FACILITY: WPPSS NUCLEAR PROJECTS NO. 3 AND NO. 5

SUMMARY OF MEETING WITH APPLICANT ON OCTOBER 29, 1974 REGARDING
SLOPE STABILITY

FIG. 2.5.64

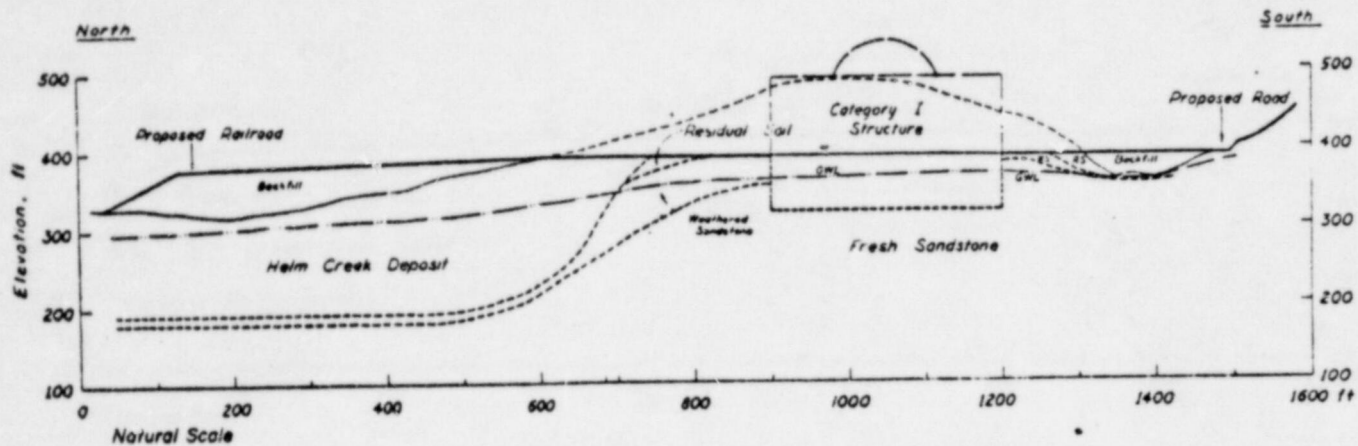
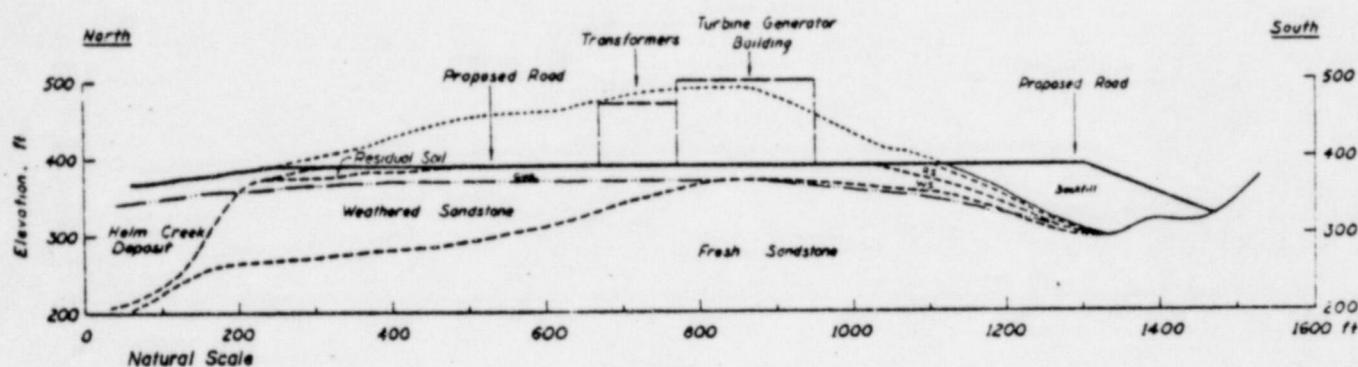
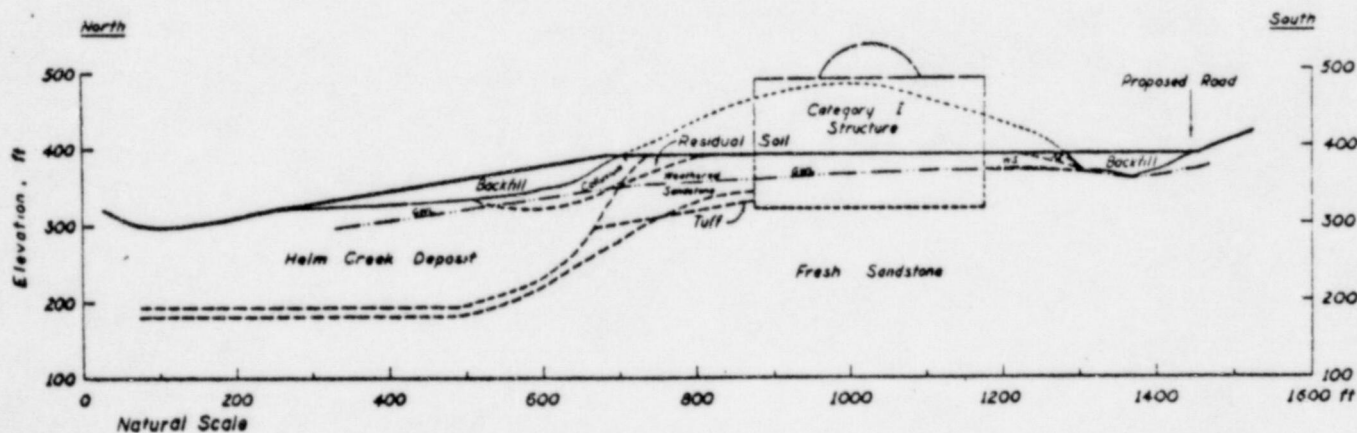
Woodward-Lundgren explained the slope stability analysis described in Section 2.5 of the PSAR. We commented that the figures in the PSAR in the slope stability subsection are not clear. As a result, we have not been able to identify the steepest slopes on these figures. We stated that the conclusions about the origin of landslides that have occurred in the site vicinity should be given more support. This will require additional field work.
